SERVICE BULLETIN

PURPOSE : INFORMATION	ISSUE NO. : MSB-12E42_54-001	DATE : 2012-07-02	
SUBJECT : OPENING THE ELECTRIC TAILGATE		<Destination/Model> (EUR) OUTLANDER	<M/Y> 13
GROUP : BODY & CHASSIS ELECTRICAL

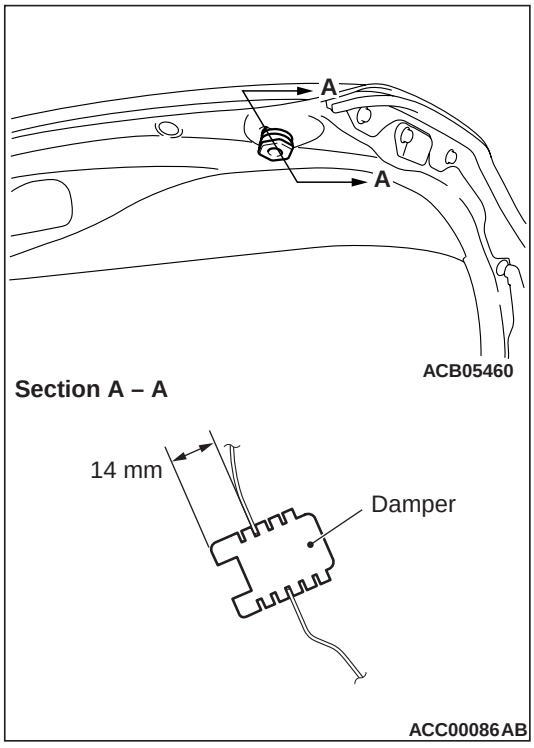
Enter the Attached sheet 3 (3/3) B

<Added>

NOTE: The setting of operation by the tailgate lock release handle with opening operation can be changed using the customisation function. Confirm which setting is activated before performing these checks. Refer to .
